Note Proposed Amendments: (added text to the code is: underlined, deleted text to the code is: ~~struck through~~)

\*Note: These amendments are “proposed only” and have not been adopted by the Department of Community Affairs.

ACTION: A (Approve as Submitted); R (Approve as Revised); D (Disapprove); W (Withdrawn); CF (Carry Forward)

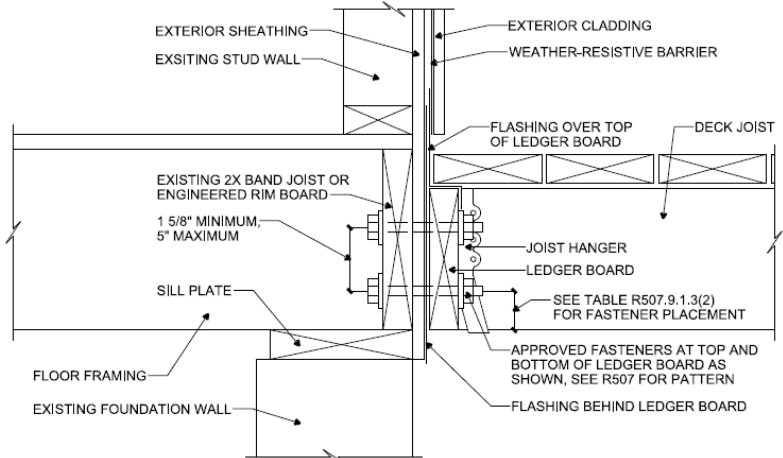
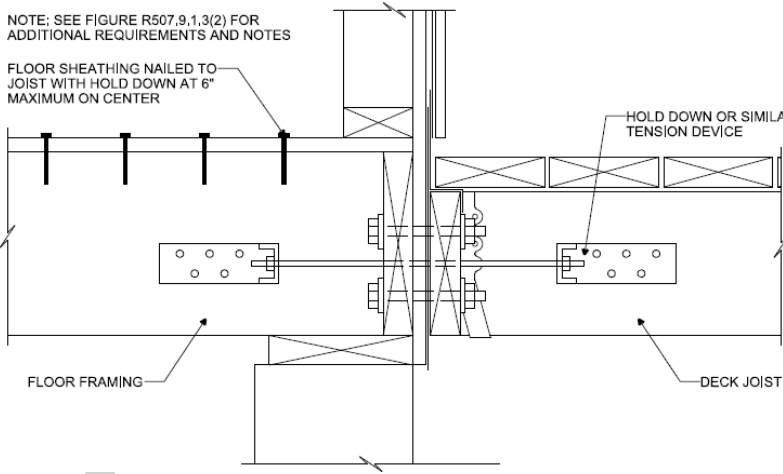
IRC-2024-31	R507.9.1.3 (2)	<p>Revise Figure R507.9.1.3(2) ‘Placement of Lag Screws and Bolts in Band Joists’ as follows:</p>  <p>The diagram illustrates the connection between an existing stud wall, exterior sheathing, and a deck ledger board. Key components labeled include: EXISTING STUD WALL, EXTERIOR SHEATHING, EXTERIOR CLADDING, WEATHER-RESISTIVE BARRIER, FLASHING OVER TOP OF LEDGER BOARD, DECK JOIST, EXISTING 2X BAND JOIST OR ENGINEERED RIM BOARD, 1 5/8" MINIMUM, 5" MAXIMUM (dimension for ledger board), SILL PLATE, FLOOR FRAMING, EXISTING FOUNDATION WALL, CLADDING, FLASHING BEHIND LEDGER BOARD, FLASHING OVER TOP OF CLADDING, JOIST HANGER, LEDGER BOARD, APPROVED FASTENERS AT TOP AND BOTTOM OF LEDGER BOARD AS SHOWN, SEE R507 FOR PATTERN, and SEE TABLE R507.9.1.3(2) FOR FASTENER PLACEMENT.</p> <p>Recommend to Carry Forward</p>	2020 amendments
